Technical Service Information

FORD AODE/4R70W STAMPED STEEL, MOLDED RUBBER 2-3 ACCUMULATOR PISTON

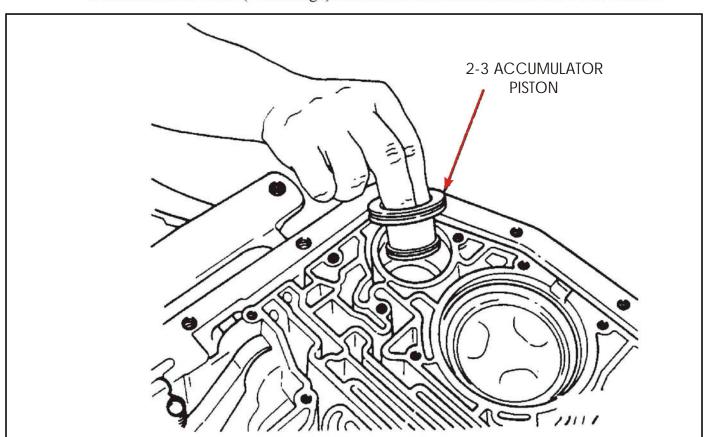
CHANGE: Beginning at the start of production for 1997 models, Ford Motor Company introduced a new design stamped steel, molded rubber 2-3 accumulator piston, for vehicles equipped with the AODE/4R70W transmission See Figures 1 and 2.

(1) Now manufactured of stamped steel with molded rubber seals instead of the previous cast aluminum piston with the individual seals. (See Figure 2).

The new design stamped steel, molded rubber 2-3 accumulator piston will retro-fit back to 1981 model hydraulic AOD transmissions, and is recommended.

2-3 Accumulator Piston (New Design) F7AZ-7H292-AA
